**Subject: MHI's Response to US-APWR DCD RAI No. 706-5339 Revision 0 (SRP 15.06.05)**

MHI's Response to US-APWR DCD RAI No. 706-5339 Revision 0

**RAI NO.:** NO. 706-5339 REVISION 0  
**SRP SECTION:** 15.06.05 – LOSS OF COOLANT ACCIDENTS RESULTING FROM SPECTRUM OF POSTULATED PIPING BREAKS WITHIN THE REACTOR COOLANT PRESSURE BOUNDARY  
**APPLICATION SECTION:** 15.6.5  
**DATE OF RAI ISSUE:** 3/1/2011

**QUESTION NO.: 15.06.05-80**

Fig-1 Comparison of the Predicted and the Measured Void Fraction (Excerpt from figure-3 of ref-[2])

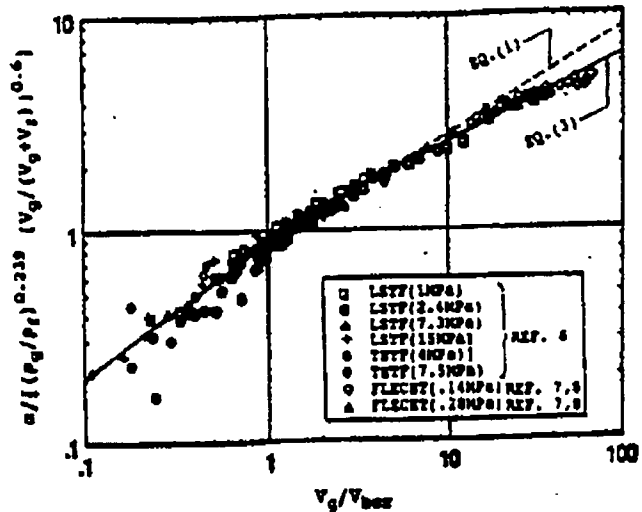
Provide the results from comparing the predictions from the level swell model, used in the US-APWR two-phase mixture level assessment during the LOCA long term cooling phase, against low-pressure level swell test data of relevance for the plant analysis.

As discussed above, the modified Yeh's correlation is utilized directly to calculate the void fraction which is used to calculate the volume of liquid in the MV. A comparison of the void fraction predicted by the correlation and the measured void fraction in several tests is shown in original paper (ref-[3]). The good agreement shows the appropriateness of the void fraction correlation including its use in the low-pressure condition (P=20 psia (0.14 MPa)). Fig-1 shows the comparison of the predicted and the measured void fraction which is described in ref-[3].
